LINOTYPE IMPROVEMENT SHEET

No. 297

KNIFE (R.H.) BLOCK (ADVERTISING)

MERGENTHALER LINOTYPE COMPANY, Brooklyn, N.Y.

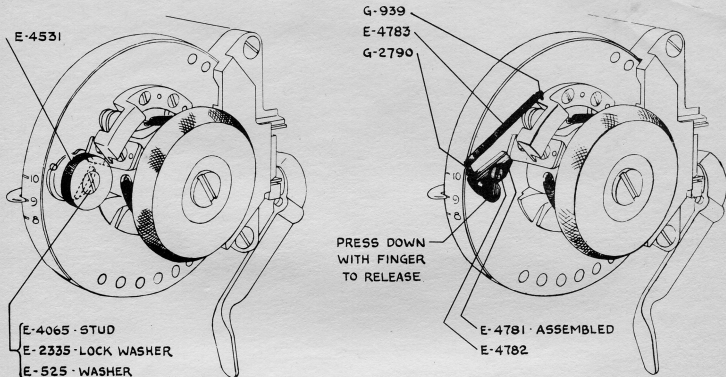
A manual latch releasing mechanism with Automatic Spring Latch Return has replaced the Sector Turn Knob and Releasing Collar (E-4531) for easier and quicker control of the (R.H.) Knife.

Can be applied to outstanding models equipped with Quick Opening Advertising Knife Block (E-4545) by removing E-4065, E-2335, E-525, E-4531 and Adding E-4781 (Assembled), E-4782, G-2790, E-4783 and drilling and tapping one hole 4x48 A.S.S.T. as shown for G-939. E-4782 uses same tapped hole formerly used for E-4065.
